PROJECT: VT RT 9, BRIDGE NO. 11
 TOWN OF WOODFORD, VT
 OVER WALDOOMSAC RIVER

TITLE: ABUTMENT CROSS FRAME

REFERENCE: PROJECT NO. ER BHF 010-1 (44)

RESUBMIT APPROVED AS NOTED
 BY C. CARLSON DATE 07-27-2012

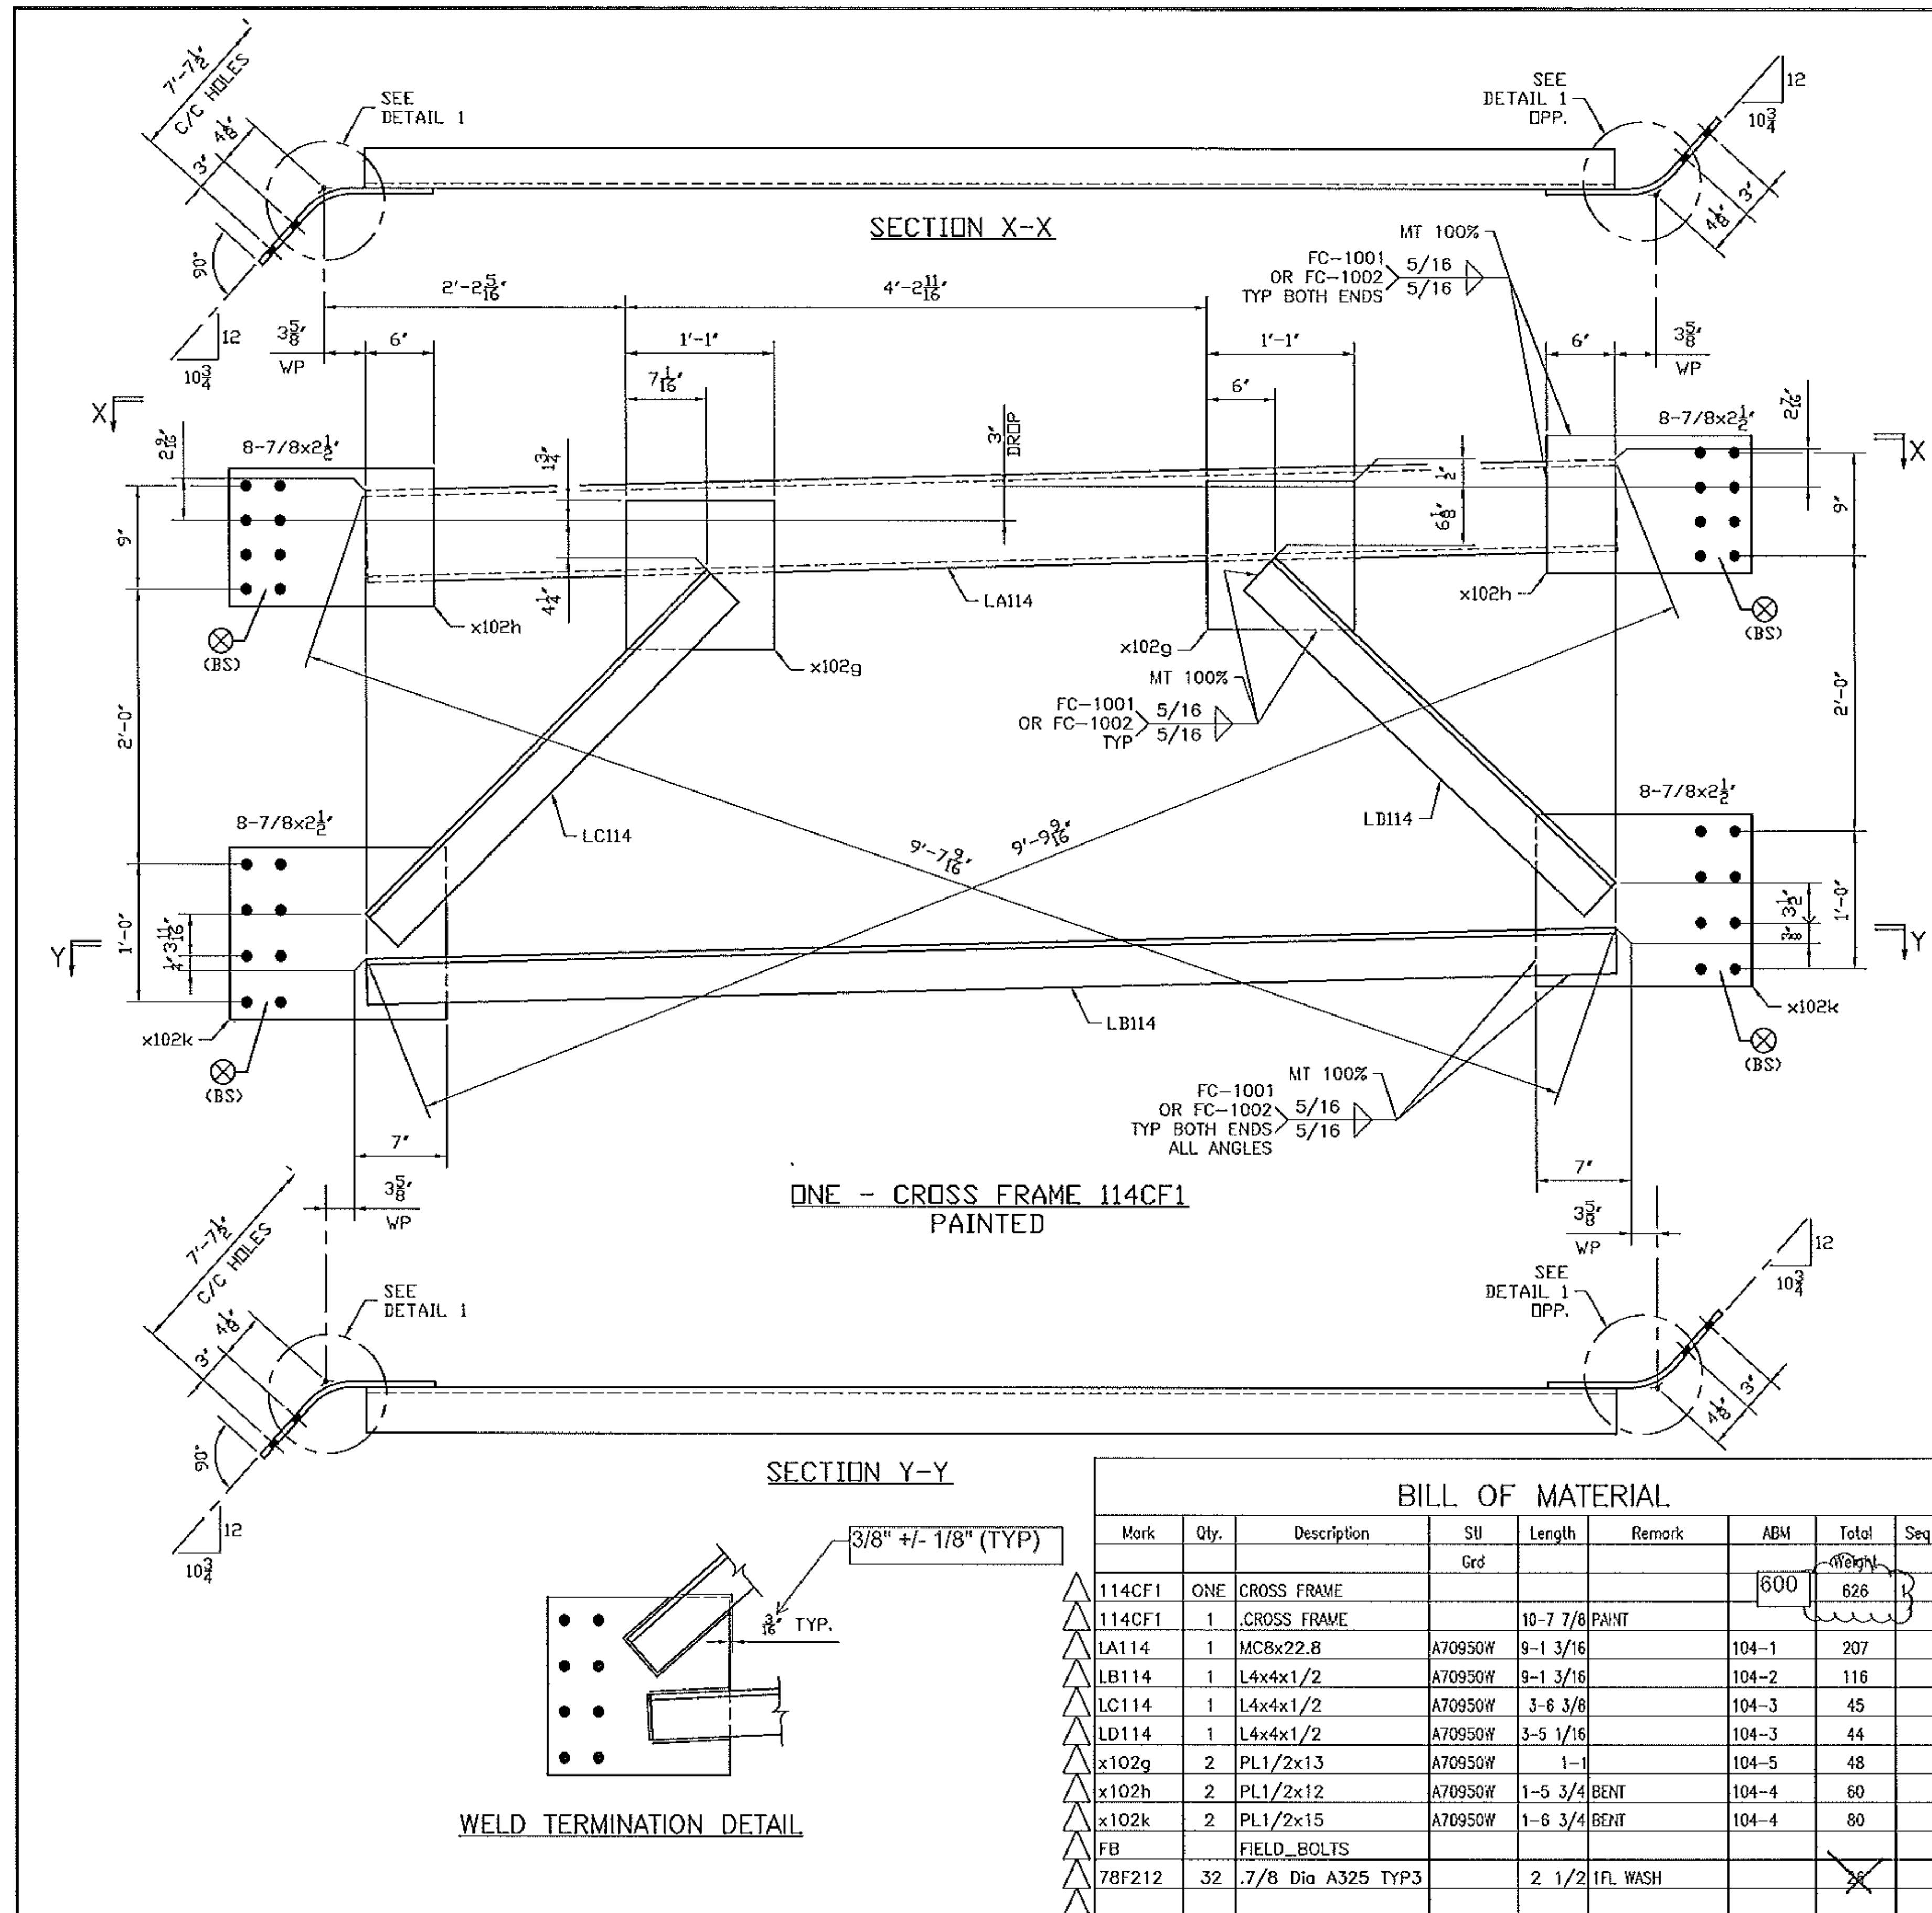
See standard specification 506.24(a)(9), no payment will be made for bolts, nuts, washers, they are considered to be incidental
